September 26, 2005

Re: Clarksburg Town Center

I. THE BOARD SHOULD MAKE CLEAR THAT THE APPLICABLE DEVELOPMENT STANDARDS ARE SET FORTH IN THE PROJECT DATA TABLE FOR THE ENTIRE CTC PROJECT AND THAT ANY VIOLATION OF THOSE STANDARDS IS A SITE PLAN VIOLATION

SITE DEVELOPMENT PLAN • PARCEL A BLOCK FF

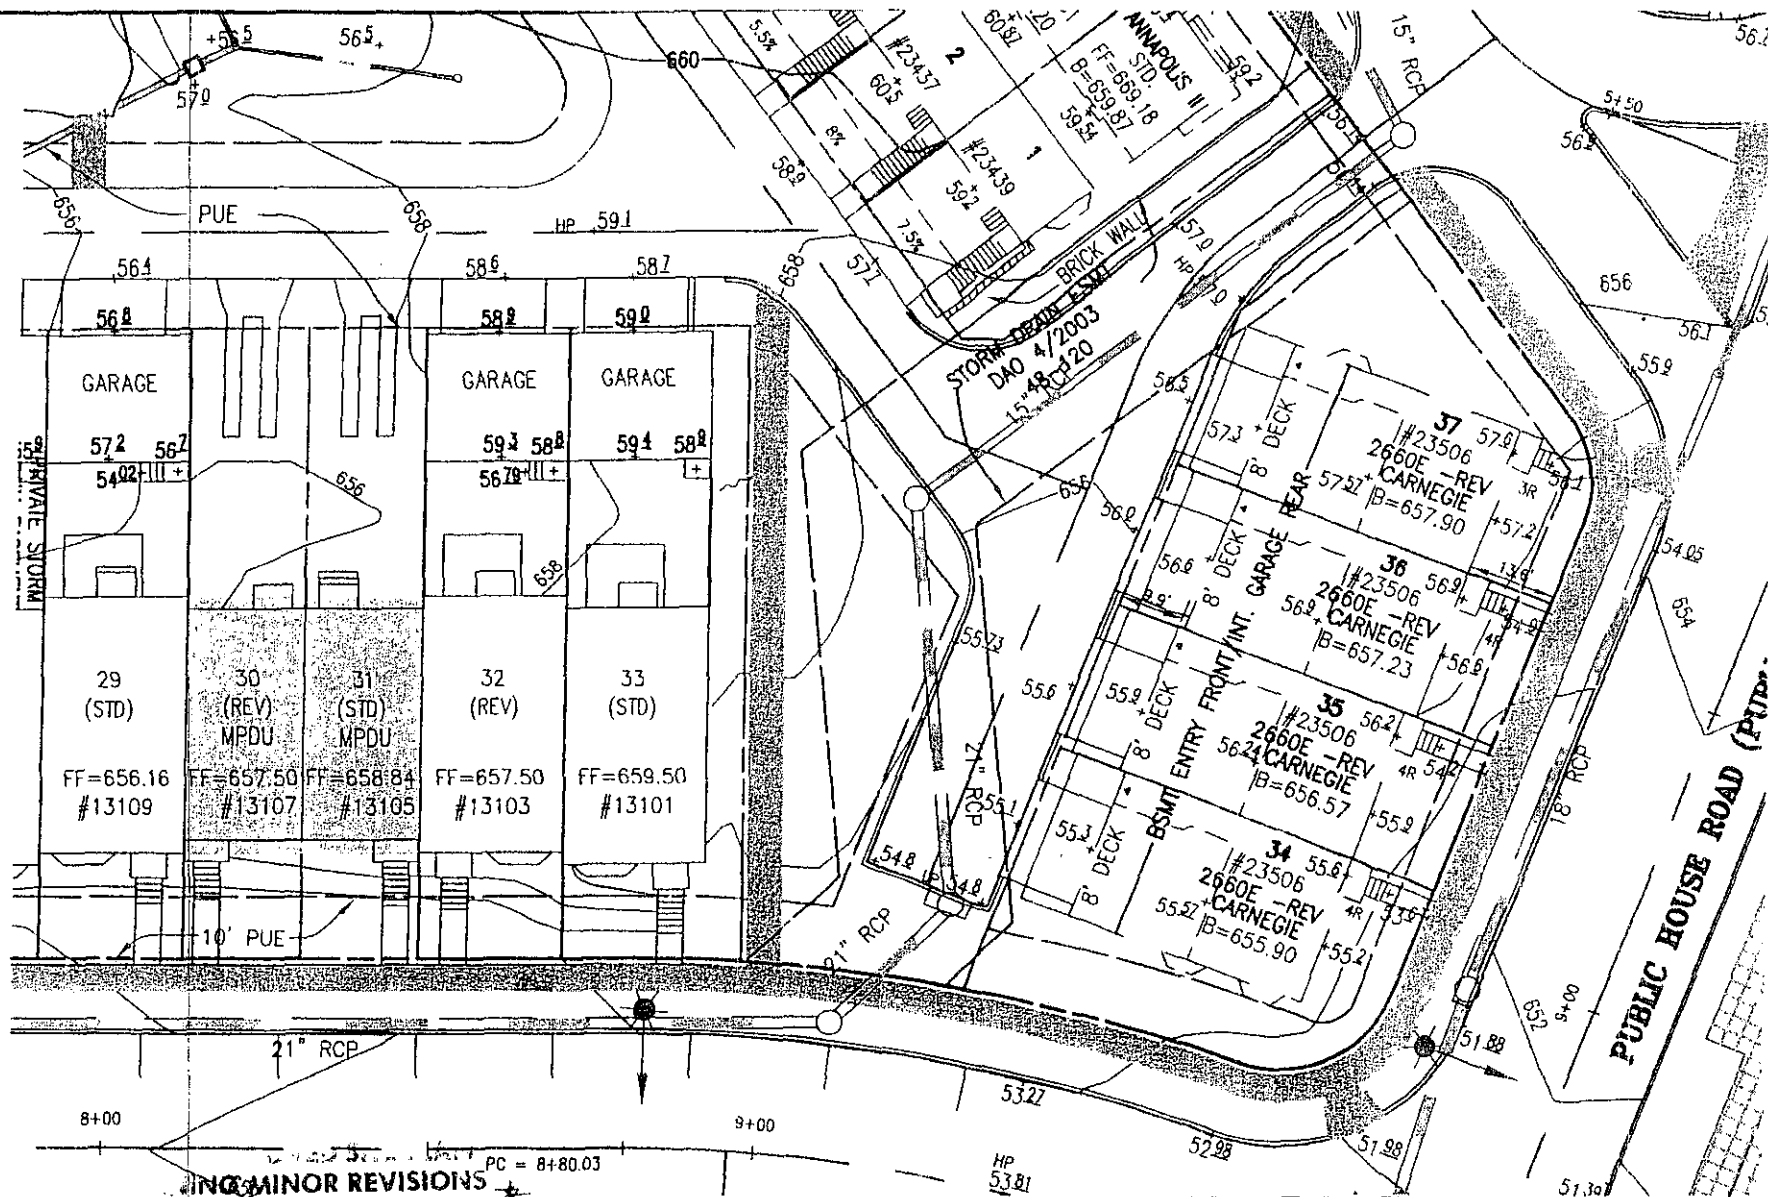
NO MINOR REVISIONS
 APPROVED BY STAFF AS SHOWN
 FILE NO. 8-98001
 OMERY COUNTY PLANNING DEPARTMENT

Remove Dumpster w/
 Unit Change
